6
A2.2
DETAIL AT EXISTING THRESHOLD
SCALE: 3/4"=1'-0"

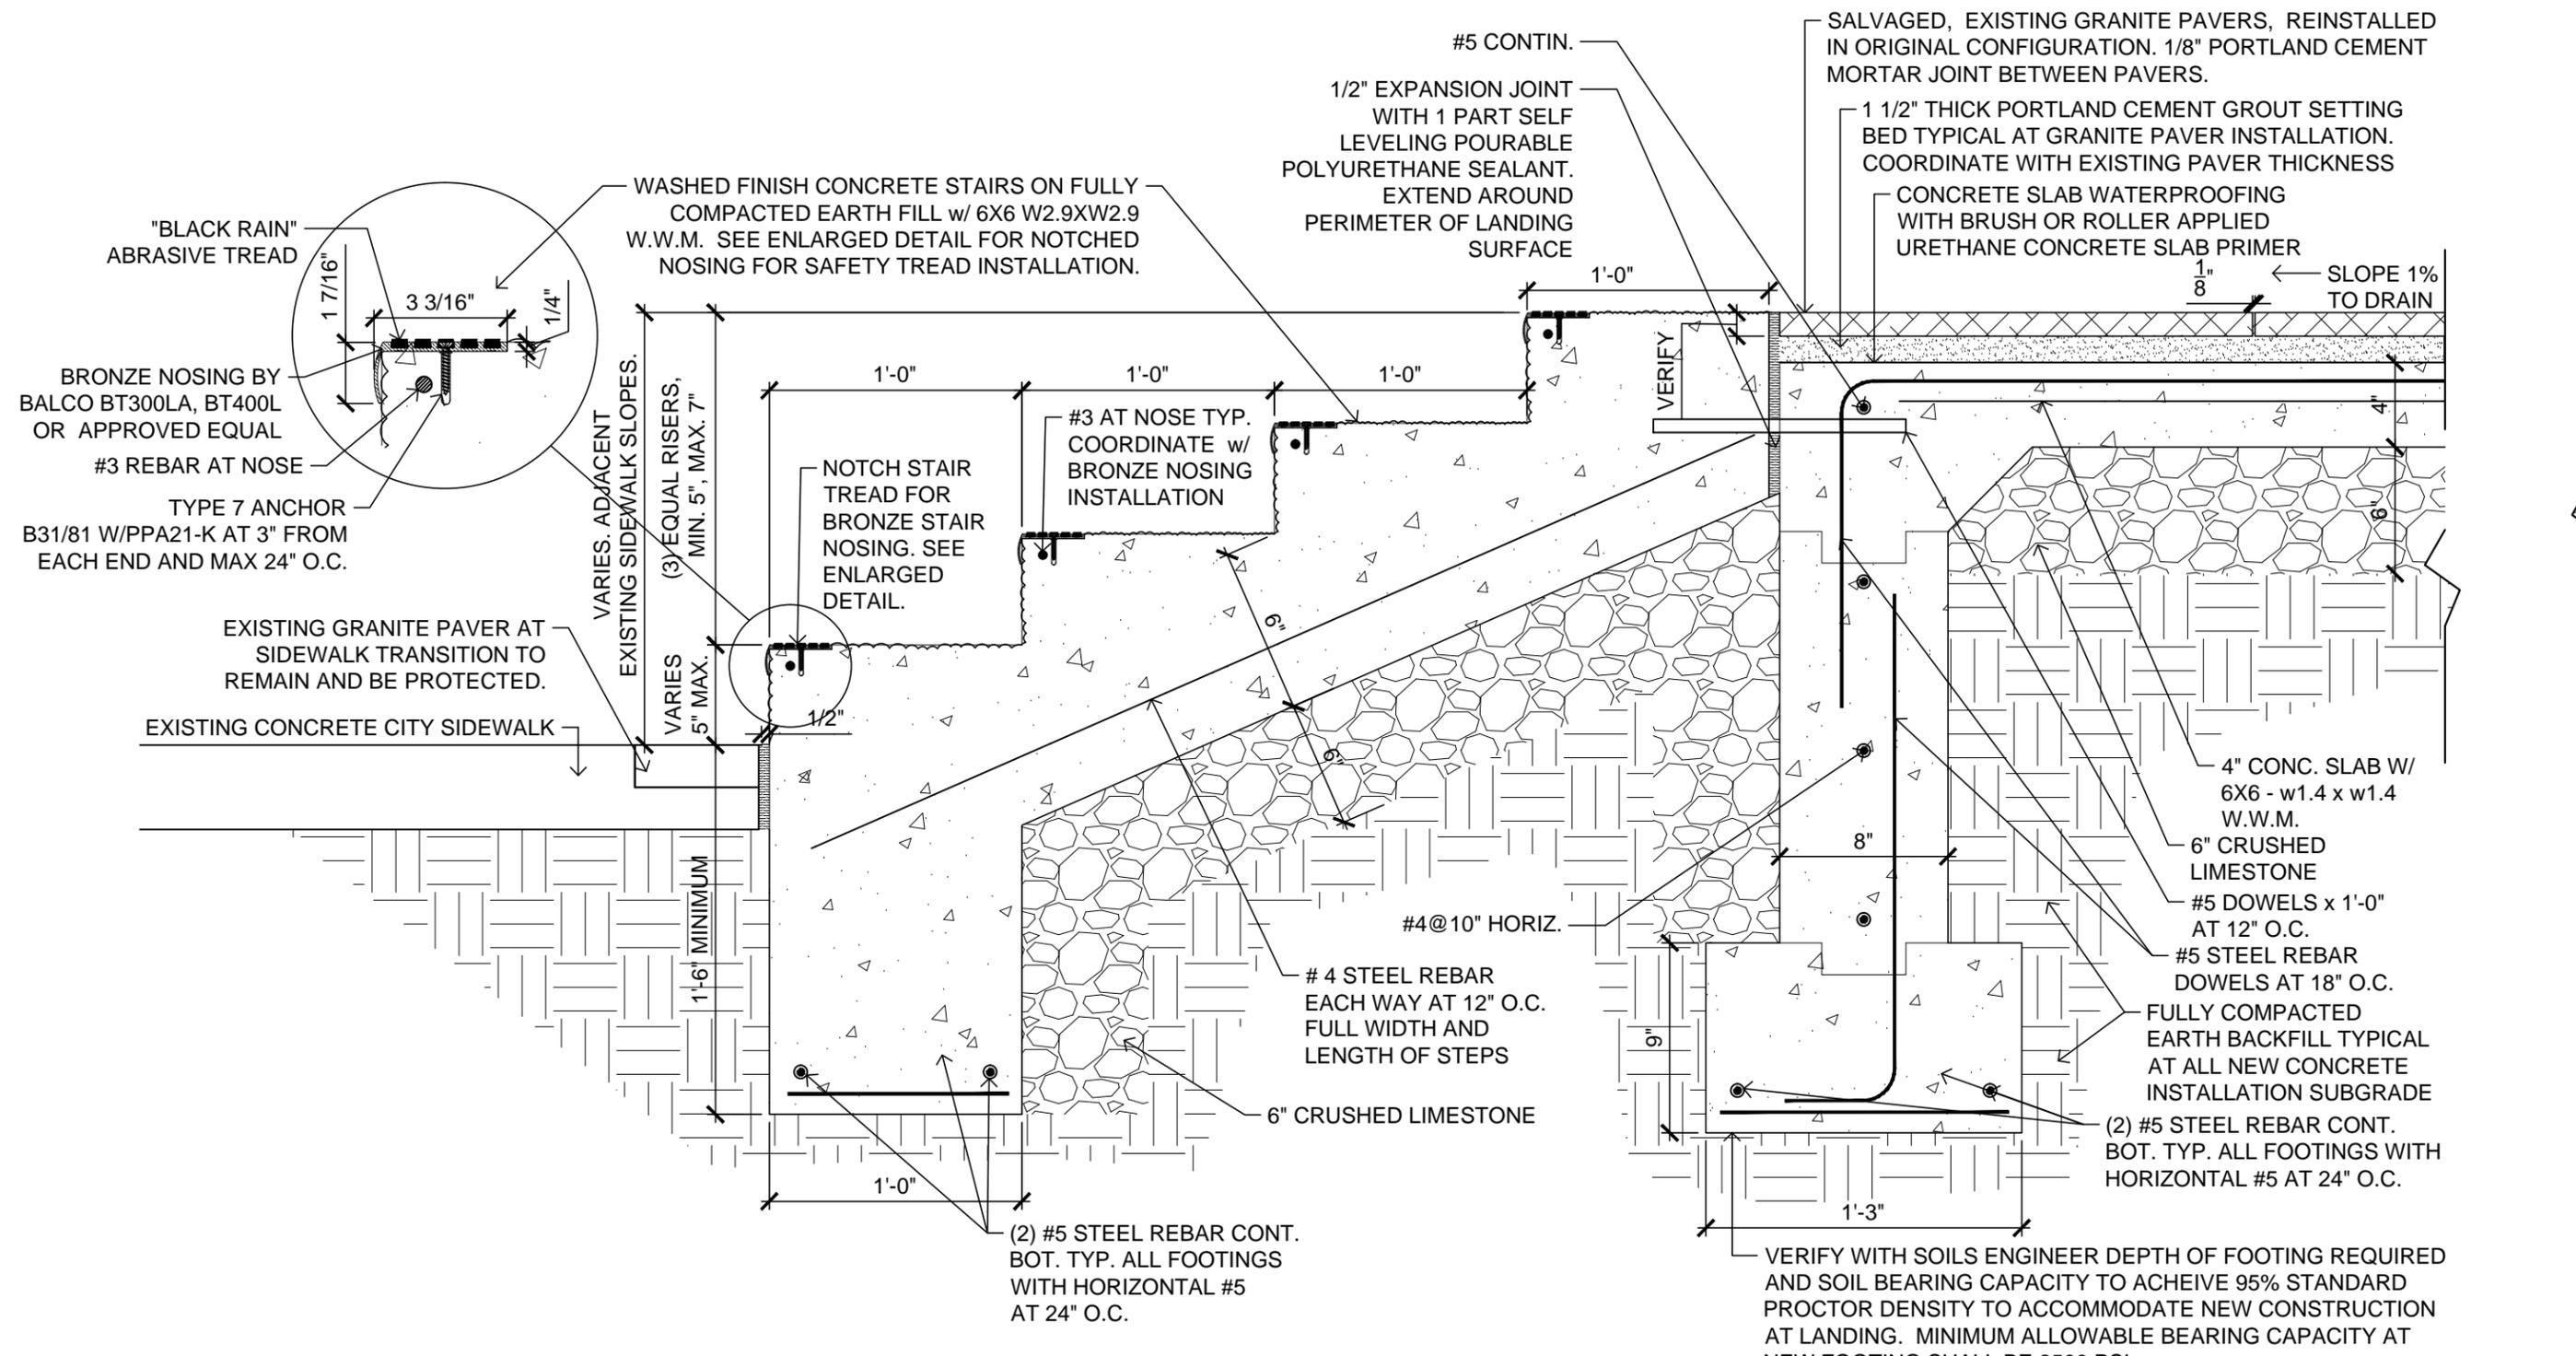
CORRECTION TO DETAIL 6/A2.2.
NOTE REFERENCING THE WELDED WIRE MESH SHOULD READ AS FOLLOWS:
4" CONC. SLAB w/6X6-w1.4 x w1.4 W.W.M., TYPICAL AT WALK AND RAMP.
